STATE OF NORTH CAROLINA
DEPARTMENT OF TRANSPORTATION

Subject: DCM Consistency for the proposed US 70 Havelock Bypass in Craven County. TIP No. R-1015. WBS 34360.1.2.

The North Carolina Department of Transportation (NCDOT) submitted additional information on Havelock Bypass to you on March 13, 2020 for review in regards to the Division of Coastal Management's CAMA Consistency Determination for the project. This package included supplemental information and revised permit drawings. Based on further coordination with the NC Division of Water Resources, further revisions need to be made to this request. This letter is a revised version of the March 13, 2020 request, showing additional and modified information highlighted in red.

PERMIT DRAWING
SHEET 124 OF 167

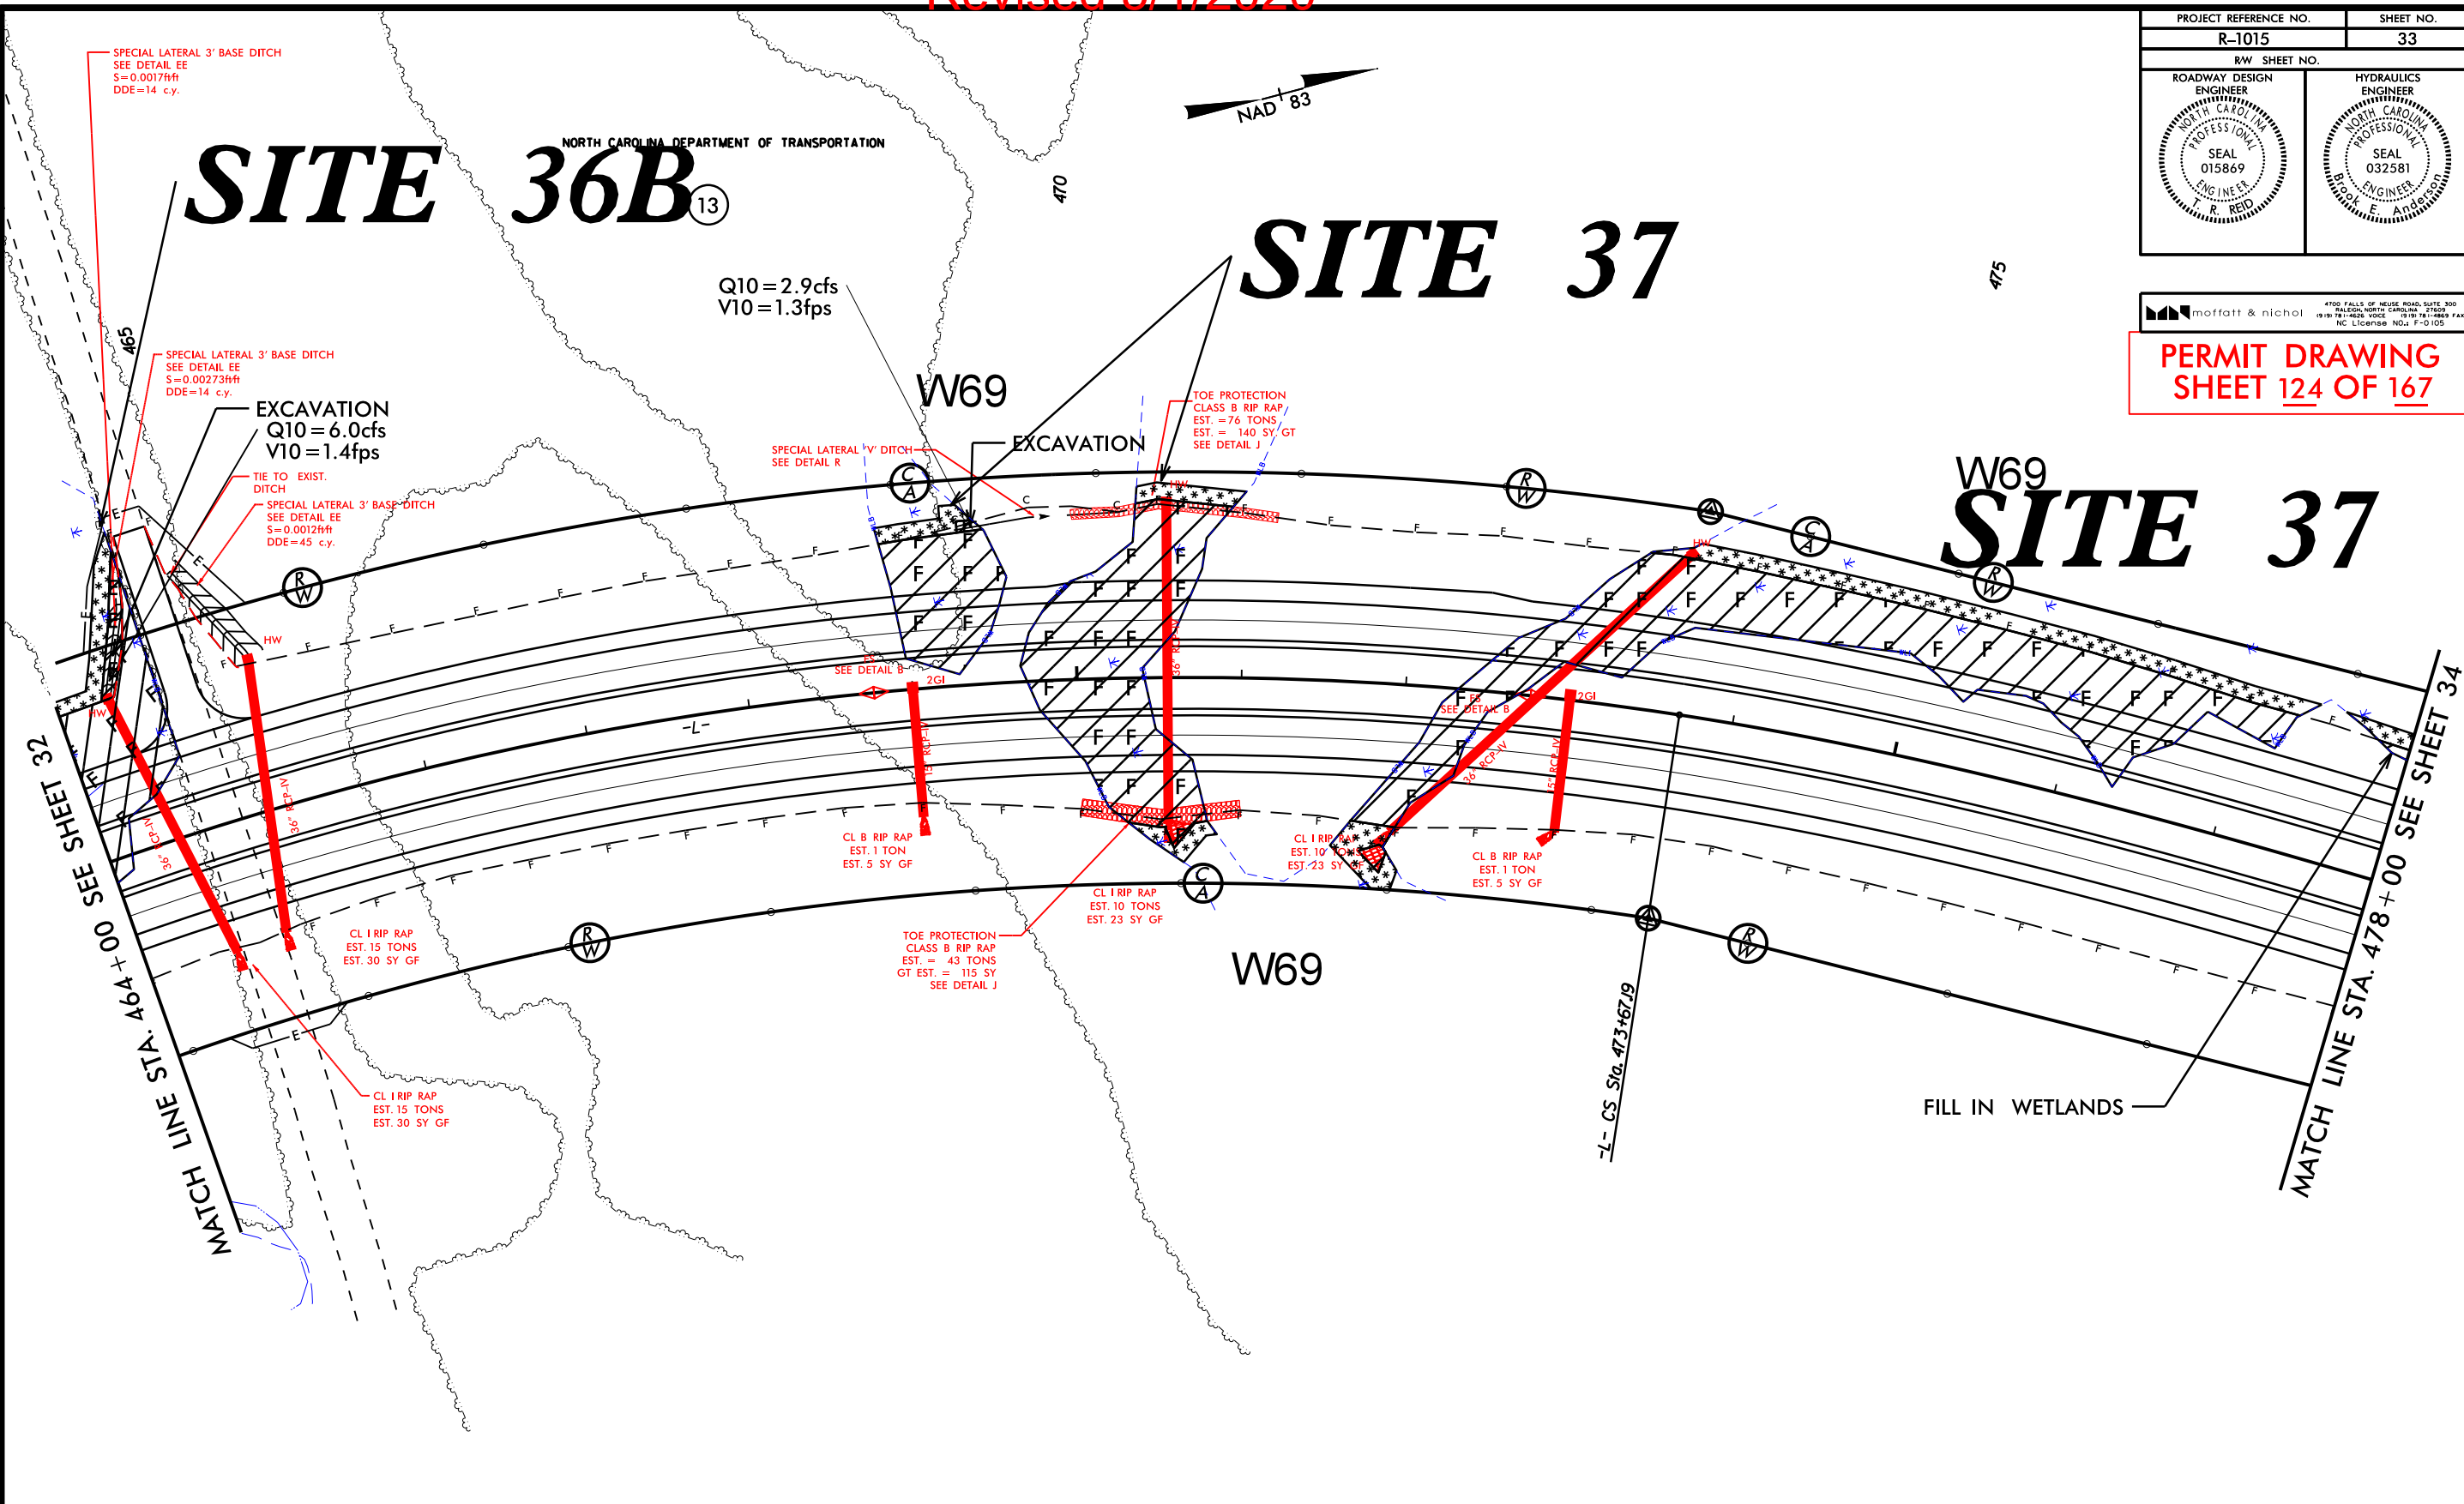
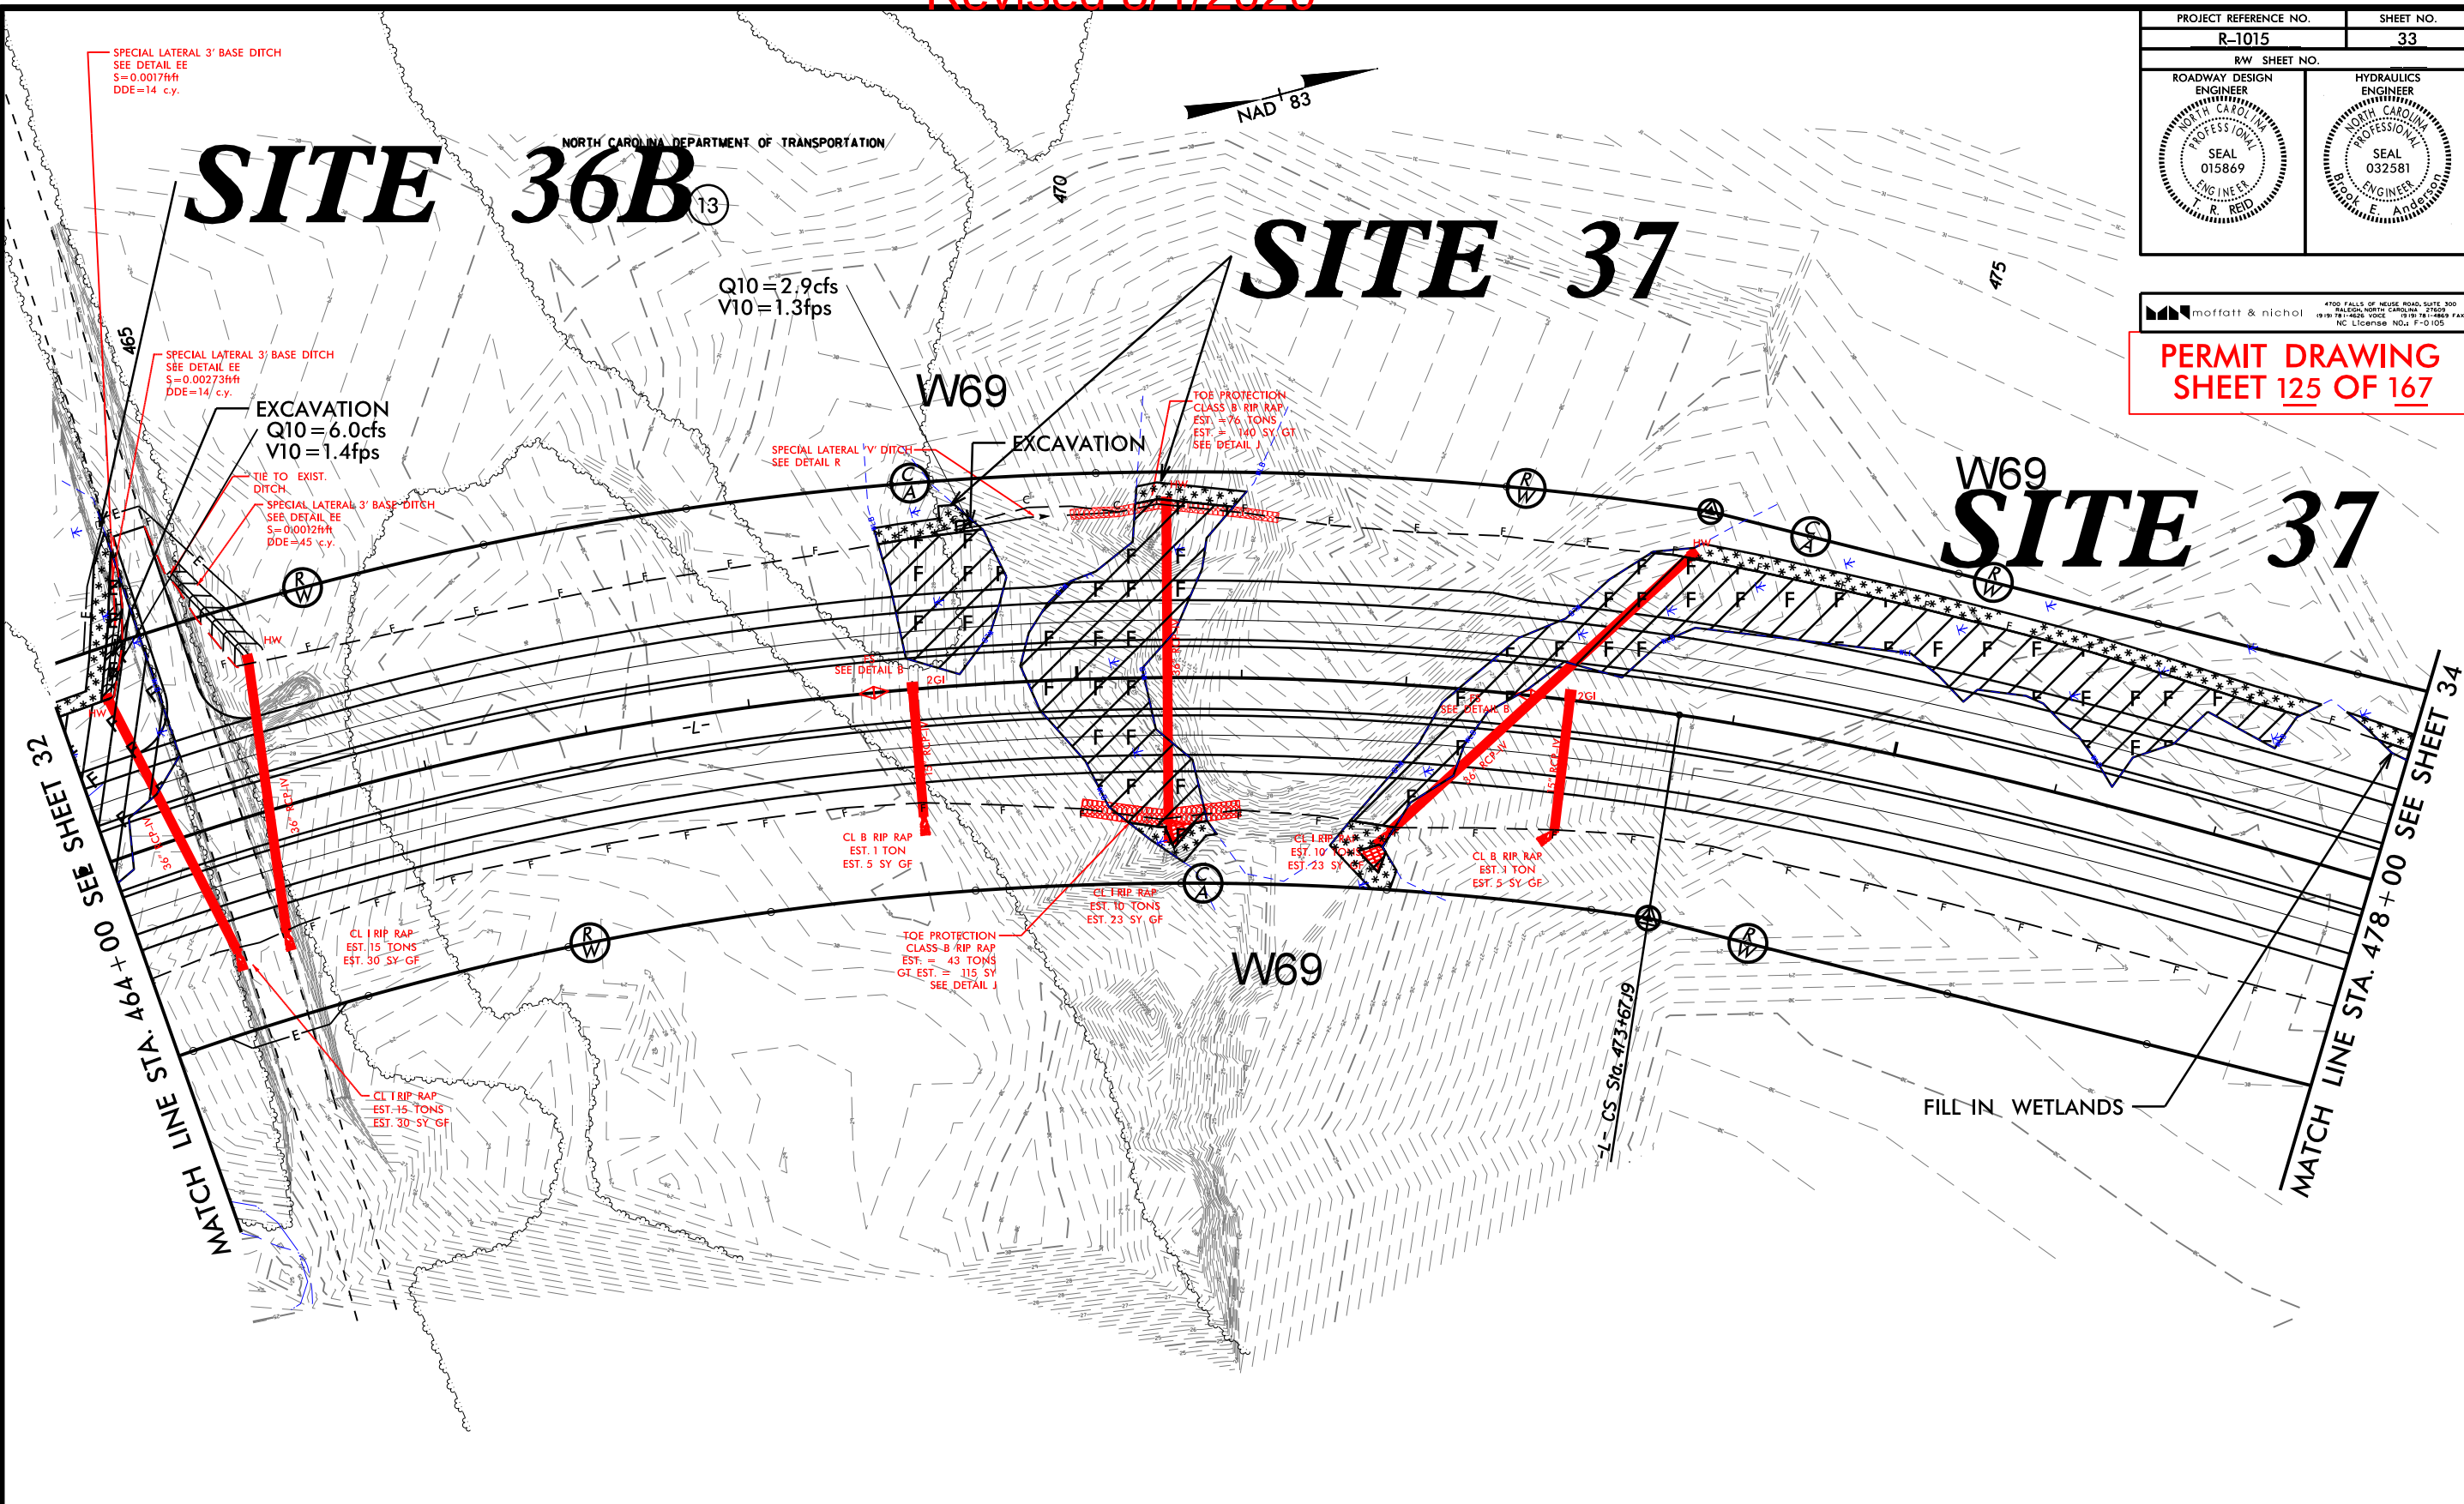
- Update to permit sheets 124 & 125. Changes were outside of impacted areas
- Update to permit sheets 130 & 131. Changes were outside of impacted areas
- Site 21 (permit sheets 148 &149) pipe outlet shifted, fill increased, excavation decreased, no change to total impacts permitted for site (0.85 acre).
